ALERT SERVICE BULLETIN

205B-24-77

MODEL AFFECTED: 205B

SUBJECT: INSPECTION OF CAP ANGLE, P/N 205-030-207-005, INTRODUCTION, OF.

Figure1. Fuselage Tailboom Attachment Inspection.

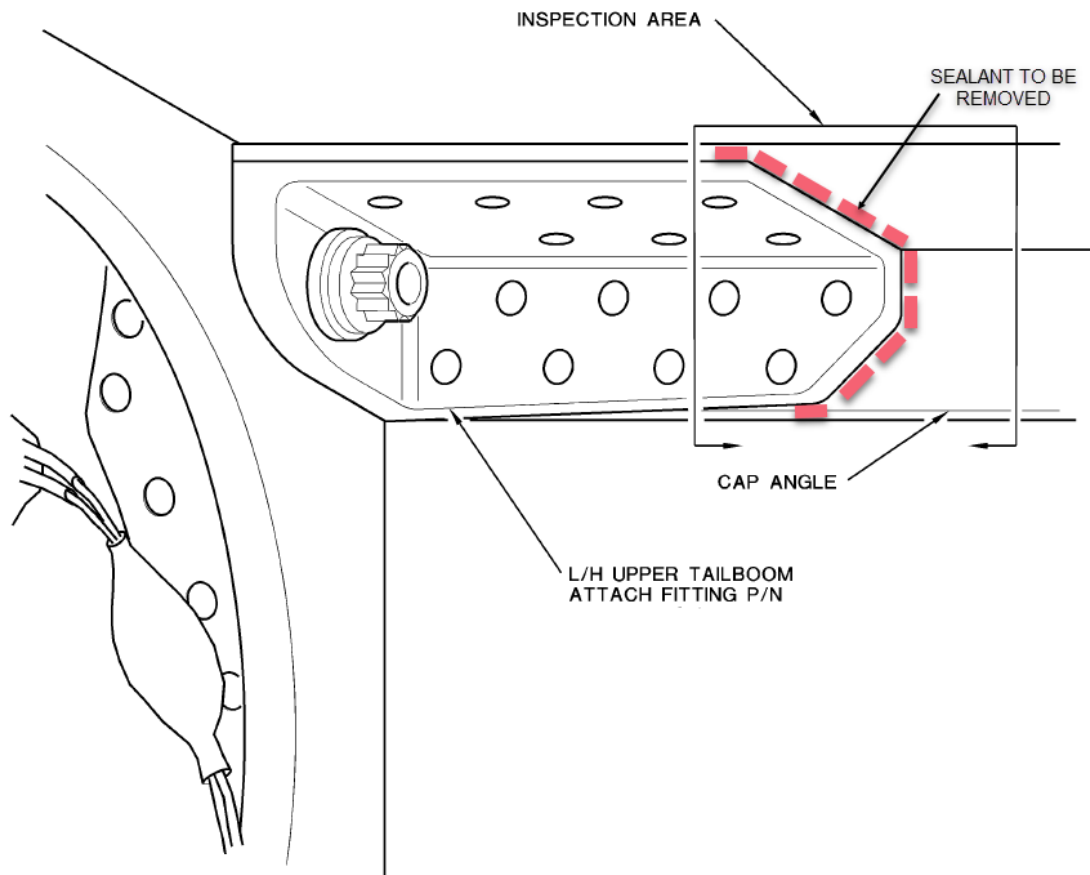
2. If sealant is present, remove sealant from edge of fitting (Figure 1).
3. Inspect the cap angle area shown with a 10x magnifying glass and bright light.
4. If a crack is found, replace the cap angle before further flight. If the helicopter is at a location where the cap angle cannot be replaced, contact Product Support Engineering.
5. Touch up primer if damaged during sealant removal. Paint touch up is optional. Do not reapply sealant.
6. If no cracks are found, the helicopter can be returned to service.
7. Make an entry in the helicopter logbook and historical service records indicating findings and compliance with this Alert Service Bulletin.
